MITIGATION PLAN

BRAHMA SITE

DMS Project ID No. 100092

Brahma Mitigation Plan IRT Comment Responses:

Scale: As Shown	FIGURE NO. 10A
Date: Sept 2019	
Project No.: 19-006

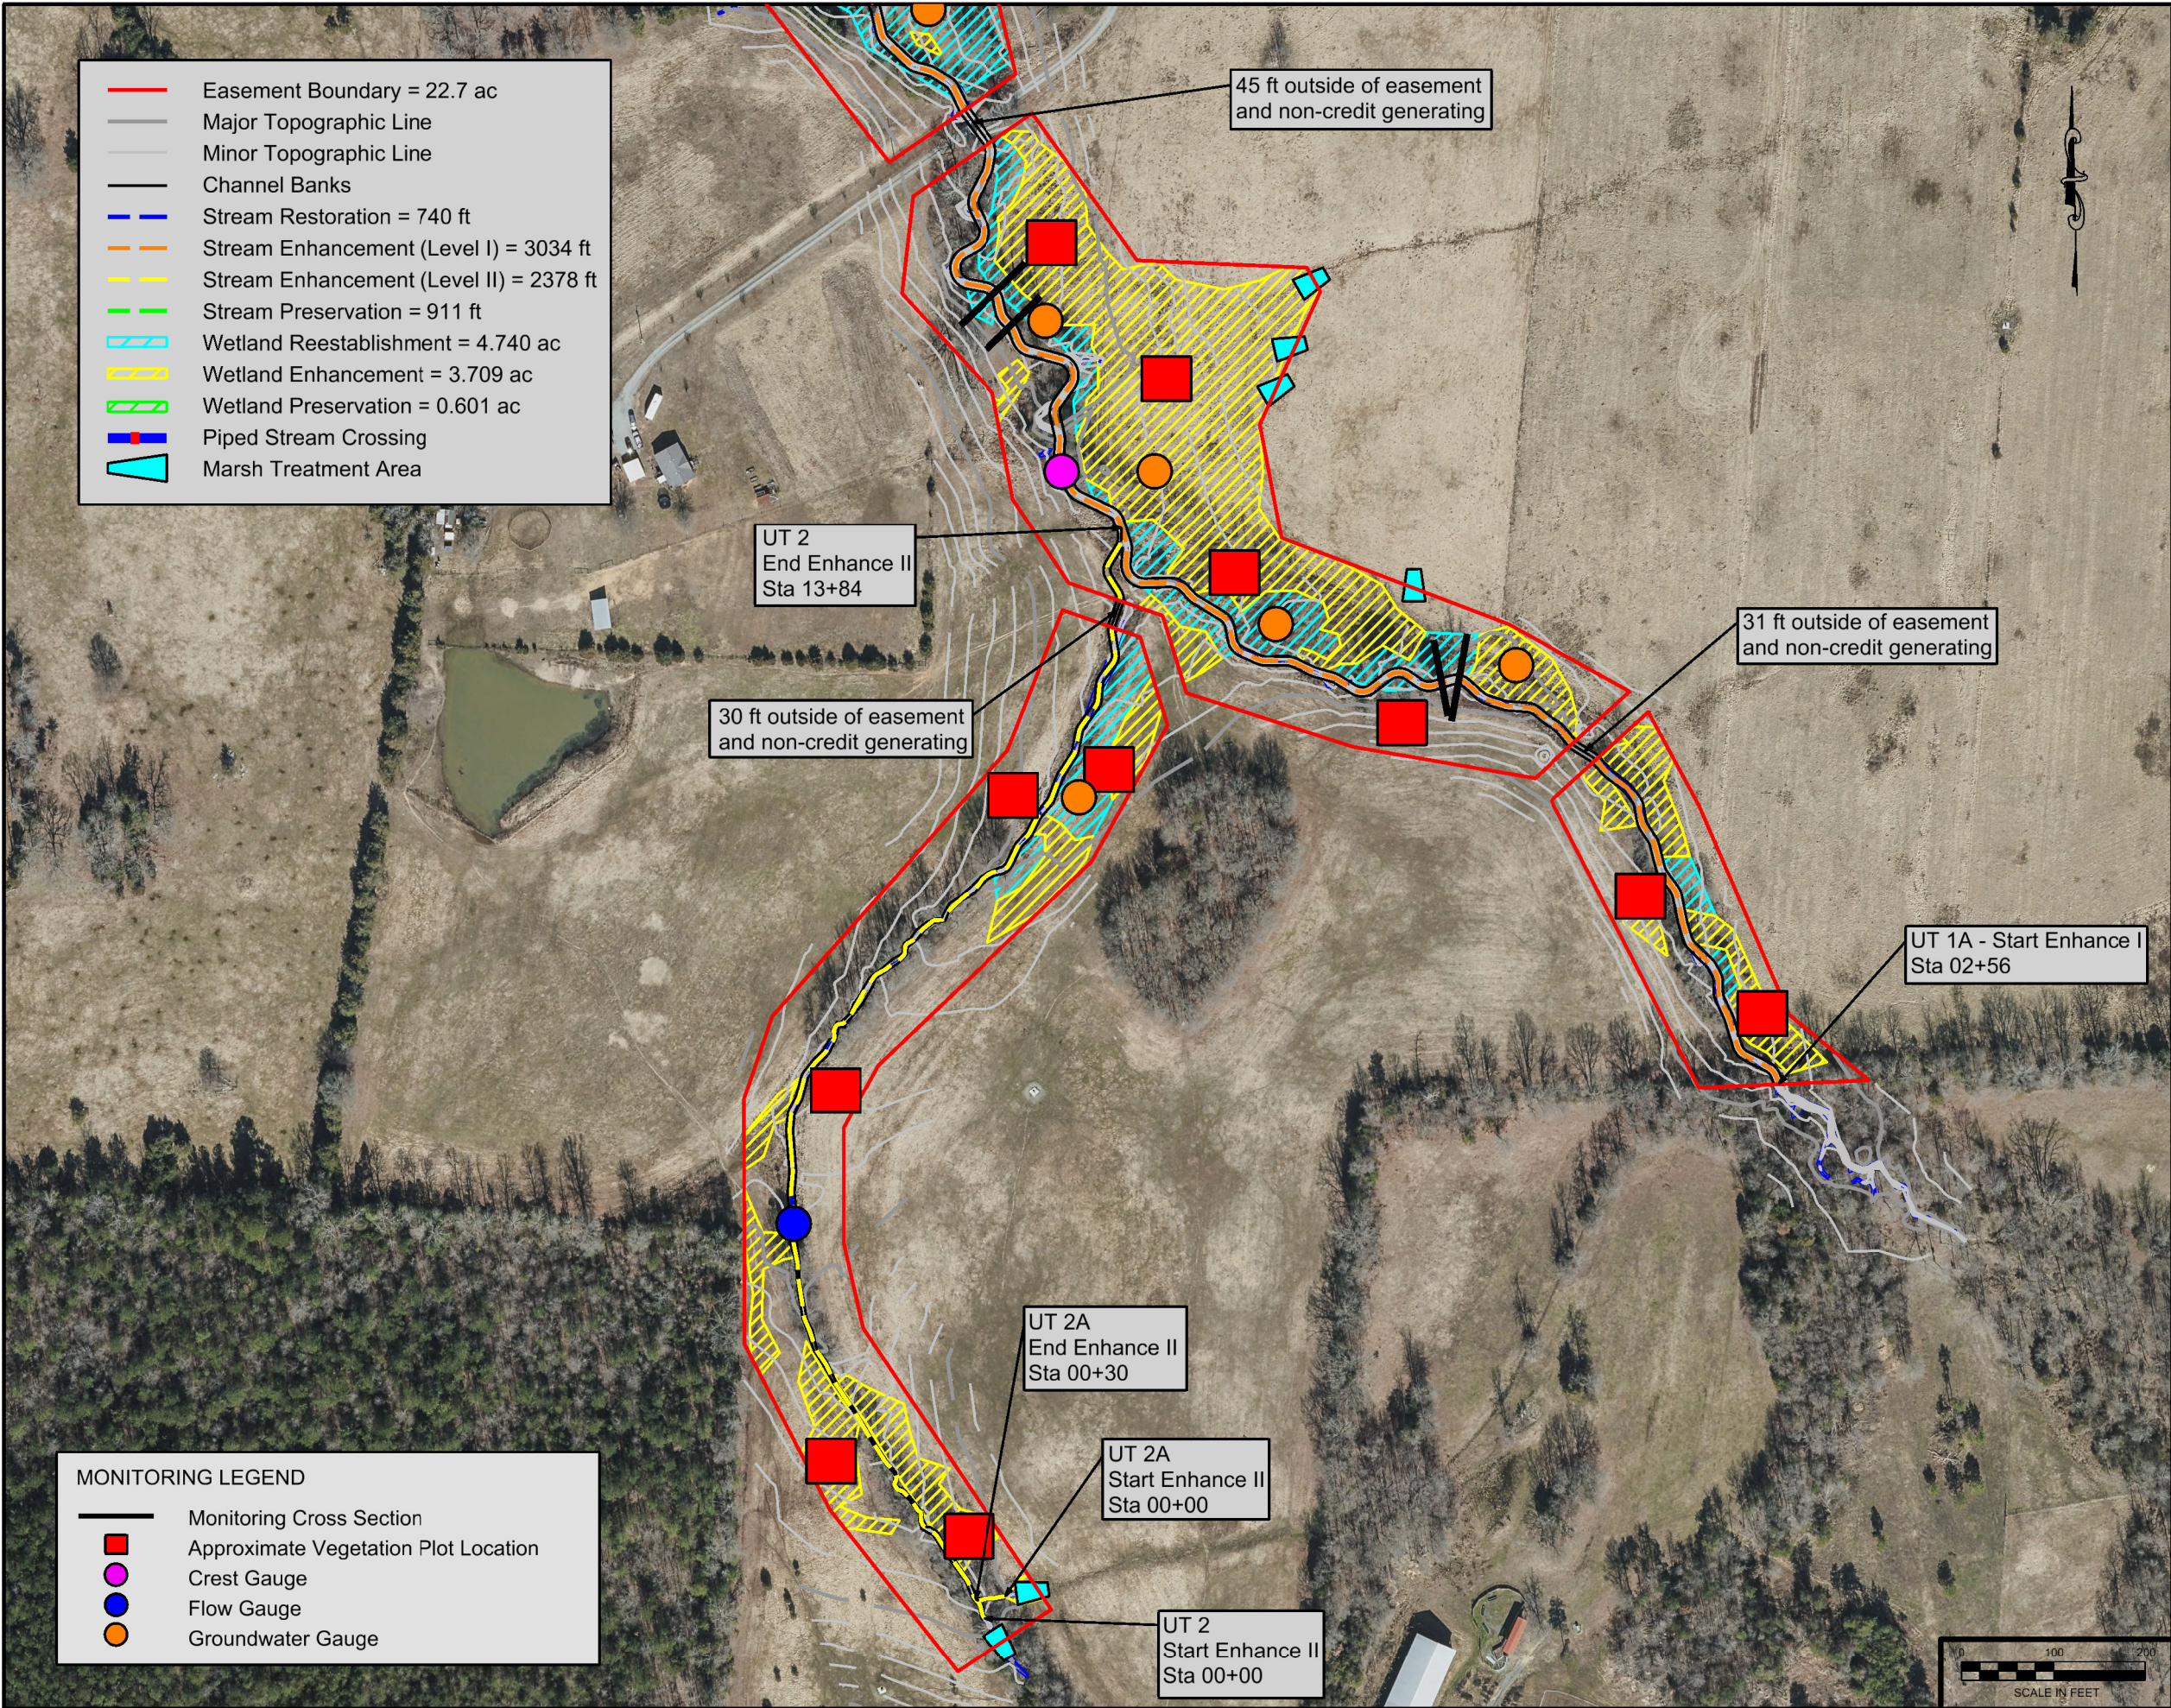
8. Design sheet 6- DWR requires a wetland monitoring gauge at station 13+25 on stream right approximately 60 feet out into the floodplain. Also, is there supposed to be another marsh treatment area (or two?). It appears that on the Monitoring Plan, Figure 10A, shows 3 marsh treatment areas.
